UNITED STATES PATENT AND TRADEMARK OFFICE

APPLICATION NO.	FILING DATE	FIRST NAMED INVENTOR	ATTORNEY DOCKET NO.	CONFIRMATION NO.
10/656,027	09/04/2003	Barry Byron	33535/US	8490

Office Action Summary

FIG.11

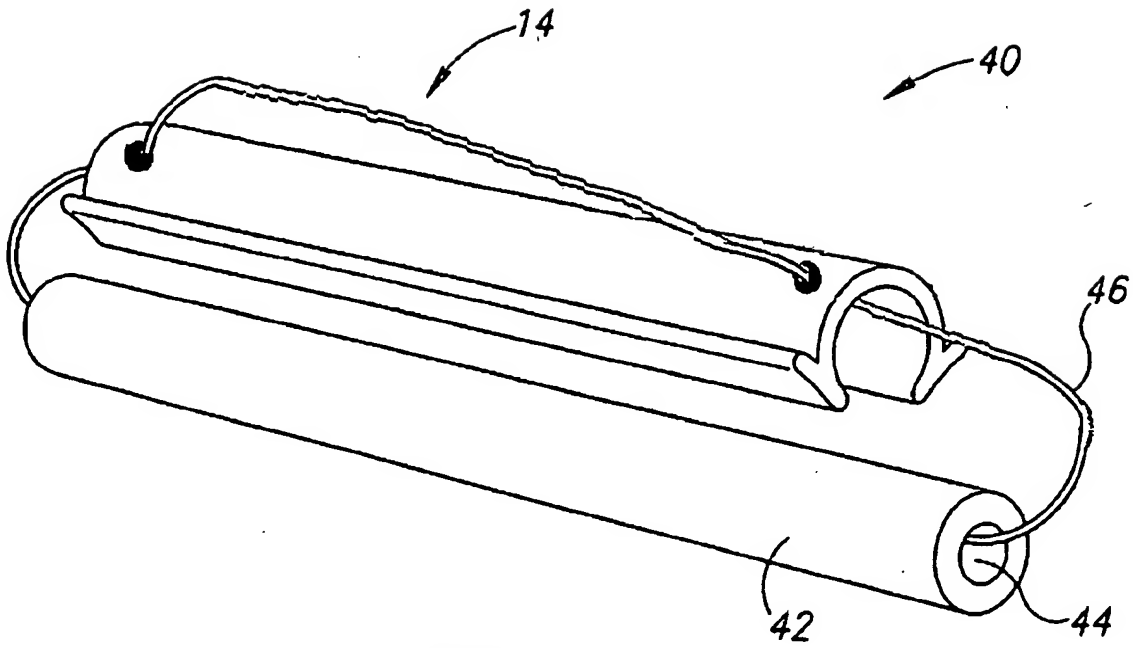
1. The disclosure is objected to because of the following informalities: There is no mention of Figure No. 11 in "Brief Description Of The Drawings" as well as in the "Detail Description of the Invention".

Newly submitted Figure No. 11 has been approved.

Appropriate correction is required.
